Verification Report

REPORT NUMBER:

009

GCL - Clarendon Road PHASE 3

VERIFICATION LAYOUT

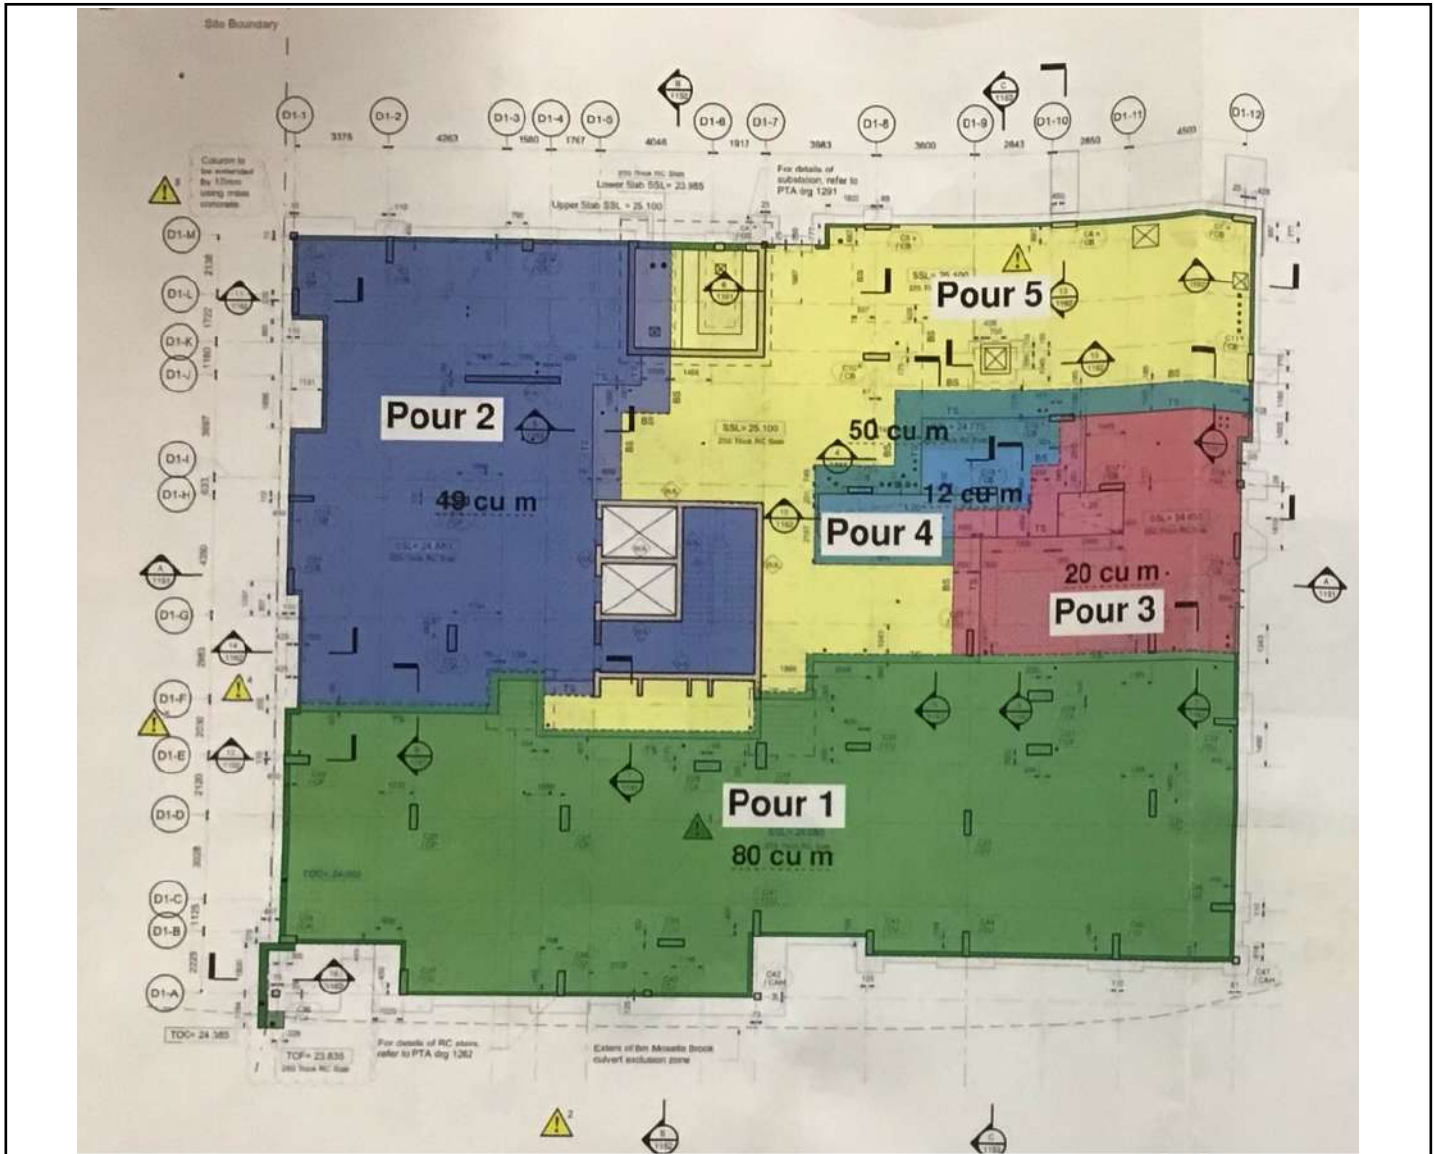
Verification of Block D1 Pour 3, 4, and 5 took place during this visit. Pour 3 and 4

have now been verified and signed off. Pour 5 will need another visit before the

area can be signed off.

VERIFICATION ITEM THREE

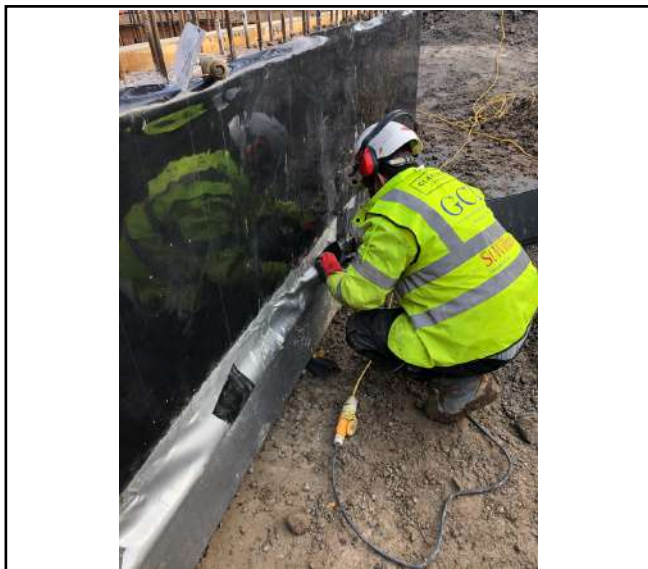
The first photograph below shows the installers have wrapped the substation. They first applied a coat of primer to all areas of concrete where the tanking had been adhered to. The installers have then welded the previously installed membrane....

... to the newly installed tanking. A large number of holes were identified in the Pudlo GP Ultra+ Gas Barrier installed to the base of the substation. As shown in both photos above the installers have patched all the holes using EXT tape and a hot air leister and roller to aid in the adherence of the patches.
